R20AR

ADDITIONAL FINAL NOTICE

DATE: December 2, 2021
TO: Blue Bird Owners
Subject: R20AR – Air Conditioner Circuit Breaker Installation

R20AR – Air Conditioner Circuit Breaker Installation

(Photo A) Correct

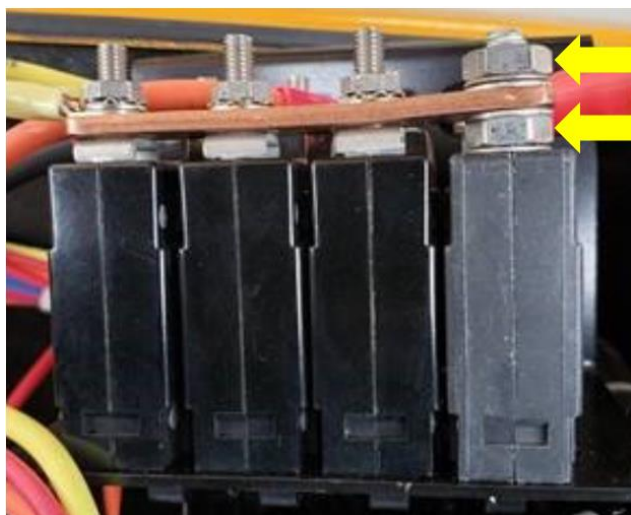
2. Visually inspect 100-amp circuit breakers for correct installation of hardware and any signs of thermal damage. As required, use a Phillips screwdriver to remove bracket mounting screws to access rear side of circuit breakers. Note: A mirror or cell phone camera can be used to visually inspect the rear side of the circuit breakers. Refer to (Photo A) on page 3 for Correct installation of hardware.

3. Refer to (Photo A) for Correct installation of hardware. If installation of hardware is correct and no visible signs of thermal damage, replace bracket mounting screws using Phillips screwdriver. Reconnect batteries or turn battery disconnect switch on if equipped, and return bus to service.

- a. Washers and #1/4-20 nut installed on top of the bus bar, as required.
- b. A #1/4-20 nut or spacer installed under the bus bar, as required.

4. Note: On some buses the #1/4-20 nut below the bus bar was NOT installed. Refer to (Photo B) for Incorrect installation. Add #1/4-20 nut if it was not installed. Torque #1/4-20 nut to 30-35 IN-LBS.

(Photo B) Incorrect

- c. A #1/4-20 nut or spacer was NOT installed under the bus bar, as required.

Note: Torque #10-32 nuts to 15-20 IN-LBS, if required.
